3.1	19 Selby Avenue, Dee Why – Demolition of an Existing Dwelling and Construction of a Two Storey Dwelling House, including Fencing and Ancillary Site Works
------------	--

DEVELOPMENT APPLICATION ASSESSMENT REPORT

Development Application No: **DA2009/0773**

Drawing Title:
Site Plan

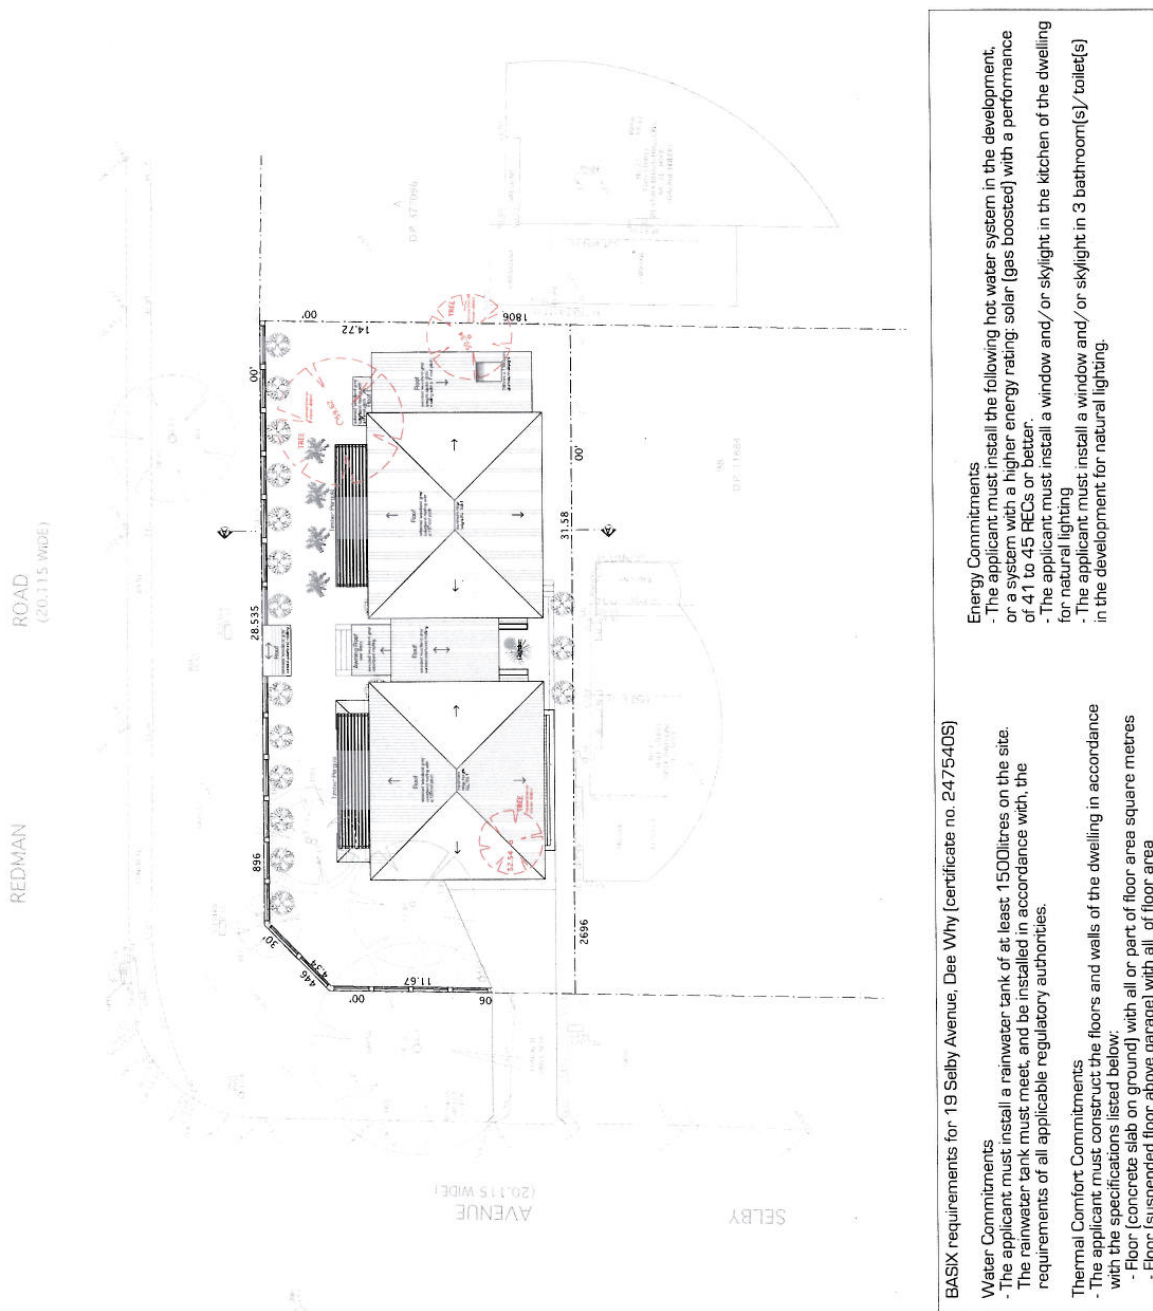
All trees which are not listed as exempt or noxious in Warringah that are not indicated for removal on Drawing No. DA02 Site Plan prepared by Dalgliesh Ward & Assoc dated 15/06/09 are to be protected.
